**RE: Slim Chicken
8240 Montgomery Blvd NE
Grading and Drainage Plans
Engineer's Stamp Date: 08/02/22
Hydrology File: G19D004E**

RE: Slim Chicken
8240 Montgomery Blvd NE
Grading and Drainage Plans
Engineer's Stamp Date: 07/05/21
Hydrology File: G19D004E

RE: **SLIM CHICKEN – ALBUQUERQUE
8240 MONTGOMERY BLVD. NE
GRADING AND DRAINAGE PLANS
ENGINEER'S STAMP 05-18-2022 (G19-D004E)**

SLIM CHICKEN	DRAWN BY
	8240 MONTGOMERY BLVD NE	pm
	GRADING AND DRAINAGE PLAN	DATE
	5571 MIDWAY PARK PL NE ALBUQUERQUE, NEW MEXICO 87109 (505) 858-3100 www.tierwestllc.com	8-2-22
		DRAWING
		2021089-GR
		SHEET #
		GR-1
		JOB #
		2021089

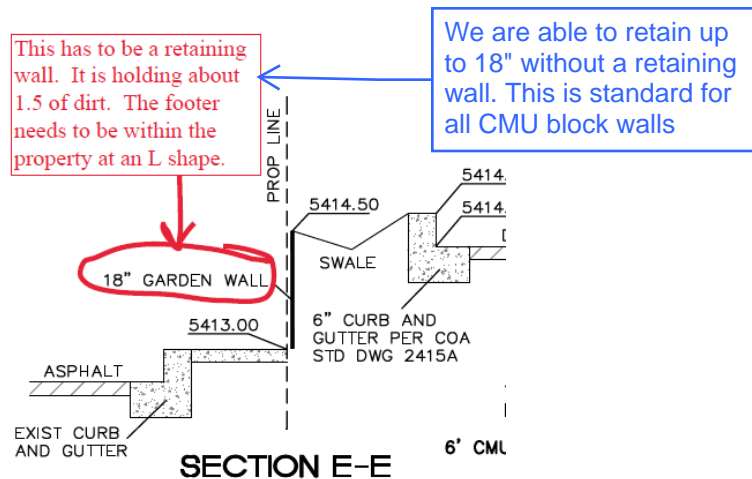
1. The retaining wall along Montgomery needs to be labeled as such in Section E-E. This also needs to show an L shaped footer within the property.

1. The retaining wall along Montgomery needs to be labeled as such in Section E-E. This also needs to show an L shaped footer within the property.
Garden walls are capable of supporting up to 18 inches of retainage before the need to be a retaining wall. The section was updated to show an L-shaped footing that does not encroach in the City right of way.

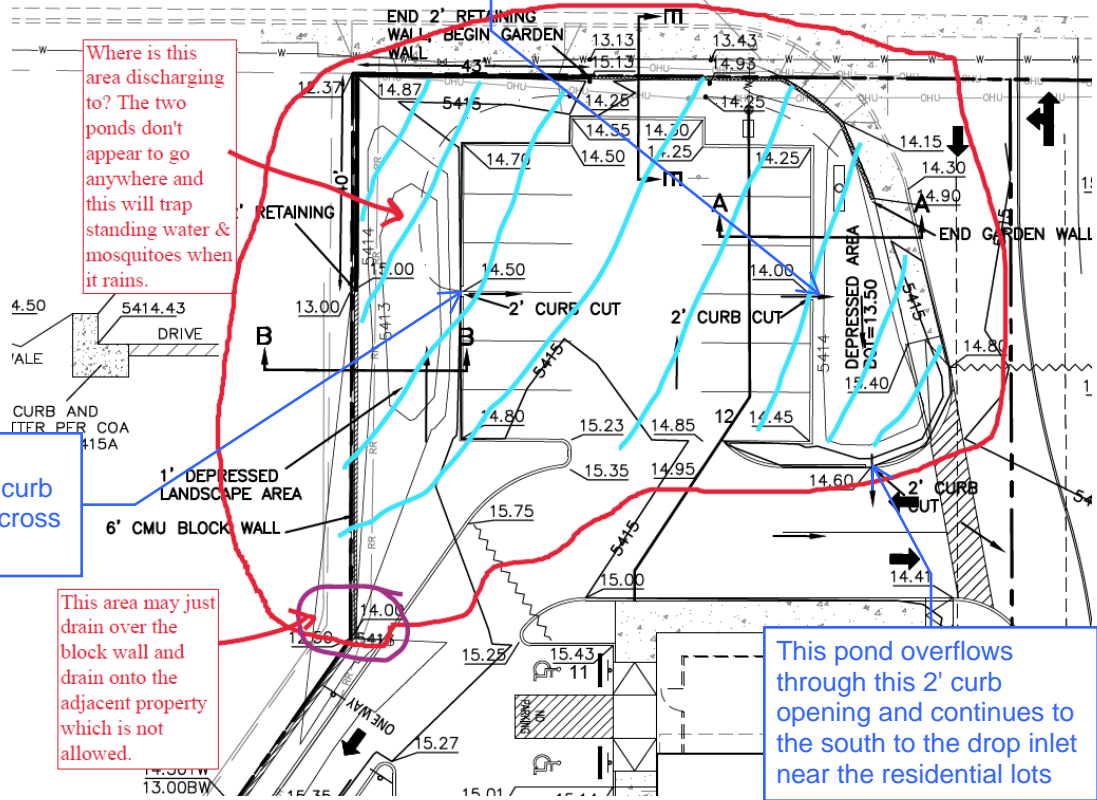
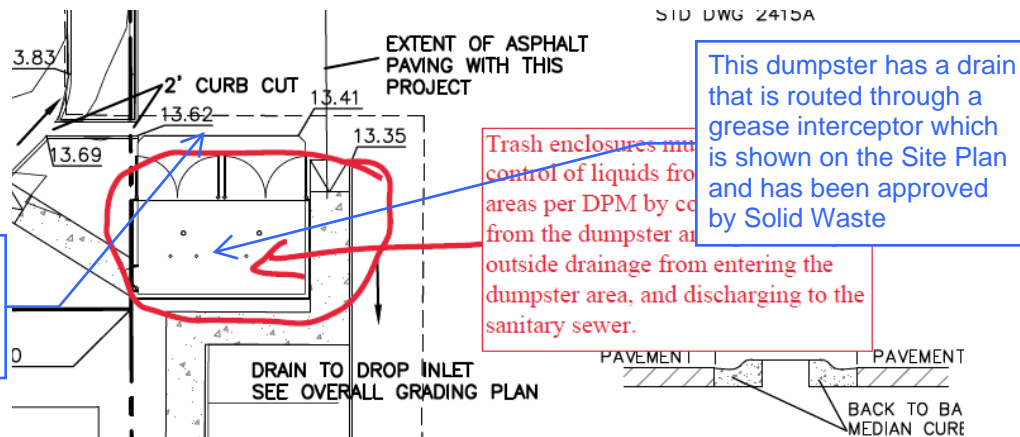
2. There is still issues with the whole parking area by Montgomery drainage. Where is this area discharging to? The two ponds don't appear to go anywhere and this will trap standing water & mosquitoes when it rains. This area may just drain over the block wall to the southwest and drain onto the adjacent property which is not allowed. Another

issue is that the depressed area of this Tract is covered by the overall development's Stormwater Quality Pond to the south next to La Mirada Place.

2. There is still issues with the whole parking area by Montgomery drainage. Where is this area discharging to? The two ponds don't appear to go anywhere and this will trap standing water and mosquitoes when it rains. This area may just drain over the block wall to the southwest and drain onto the adjacent property which is not allowed. Another issue is that the depressed area which is not needed since this Tract is covered by the overall development's Stormwater Quality Pond to the south next to La Mirada Place.
As stating in the Proposed Drainage Narrative and in the previous response letters these areas are passive water harvesting areas that overflow through 2' wide curb cuts. All drainage flows to the southeast corner of the property per the Overall Drainage Plan and drain to a drop inlet near the residential neighborhood. We had previously place flow arrows on the plan showing direction of flow and how these depressed landscaped areas drain through the curb openings. We have no added a note to each areas stating that these depressed landscaped areas overflow through the 2' curb openings. The only storm water that is in these areas is what falls on it and will either infiltrate the ground or evaporate prior to the gestation period of mosquitoes.

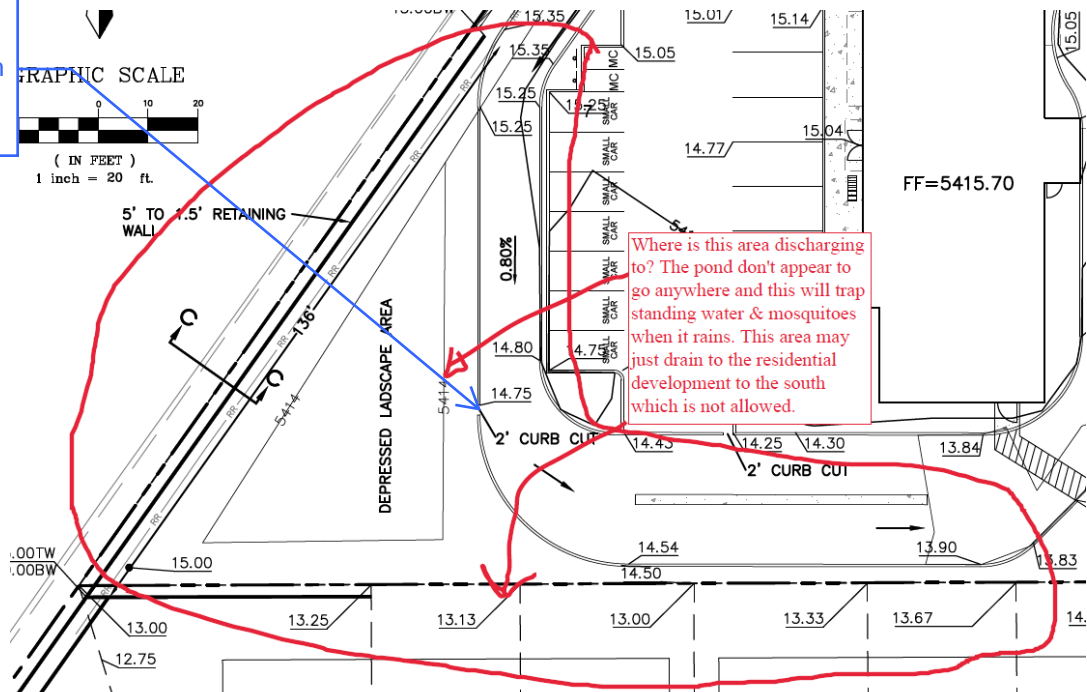
- The low area in the Southwest corner has some drainage issues. Where is this area discharging to? The pond doesn't appear to go anywhere and this will trap standing water & mosquitoes when it rains. This area may just drain to the residential development to the south which is not allowed. Again there is an issue is that the depressed area which is not needed since this Tract is covered by the overall development's Stormwater Quality Pond to the south next to La Mirada Place.

This pond overflows through this curb opening to the east and then south to the drop inlet near the residential lots.

4. The low area in the Southwest corner has some drainage issues. Where is this area discharging to? The pond doesn't appear to go anywhere and this will trap standing water and mosquitoes when it rains. This area may just drain to the residential development to the south which is not allowed. Again there is an issue is that the depressed area which is not needed

since this Tract is covered by the overall development's Stormwater Quality Pond to the south net to Las Mirada Place.

As stating in the Proposed Drainage Narrative and in the previous response letters these areas are passive water harvesting areas that overflow through 2' wide curb cuts. All drainage flows to the southeast corner of the property per the Overall Drainage Plan and drain to a drop inlet near the residential neighborhood. We had previously place flow arrows on the plan showing direction of flow and how these depressed landscaped areas drain through the curb openings. We have no added a note to each areas stating that these depressed landscaped areas overflow through the 2' curb openings. The only storm water that is in these areas is what falls on it and will either infiltrate the ground or evaporate prior to the gestation period of mosquitoes. There is also a CMU block wall along the west property line that will prevent any flows from entering or existing this parcel from/to the residential development to the west.
